SOLAR IMPACTS TO PRINCETON

Walsh Analysis

1. SOLAR IMPACTS TO PRINCETON

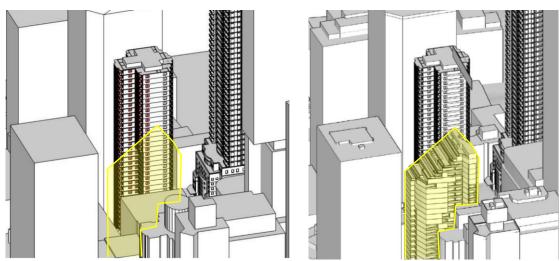
It has been noted that our Solar Analysis was different to the Stage 1 Solar Access Report by Steve King. Below we have created a comparison table to highlight the differences (all based on 116 units).

Firstly we reviewed the Methodology of Steve King as outlined in Part 5.1 and note it is an identical methodology to what we have used as outlined in part 4.2 of our report. We have also reviewed the characterisation of overshadowing is outlined in Part 6.2 of the Steve King report, which references objective 3B-2 of the ADG. Our characterisation is also outlined in part 6.2 of the report and is the same.

We have reviewed the old report and we note that there are many external factors that lead to the differences in the results of Steve King verse Walsh² Analysis. The main external factor that leads to this difference is the Development Application Approval of 116 Bathurst Street Sydney; which has been included in our analysis but not in Steve Kings report (possibly not approved at the time). The two below images demonstrate some of the impact this approval has on Princeton Apartments, with a significant increase to overshadowing to Princeton Apartments.

Based on the above, the existing 'base case' analysis of Princeton Apartments as noted in Table 2, part 6.3 of our SSDA report are the existing numbers that should be referenced as they include the Development Application Approval of 116 Bathurst Street.
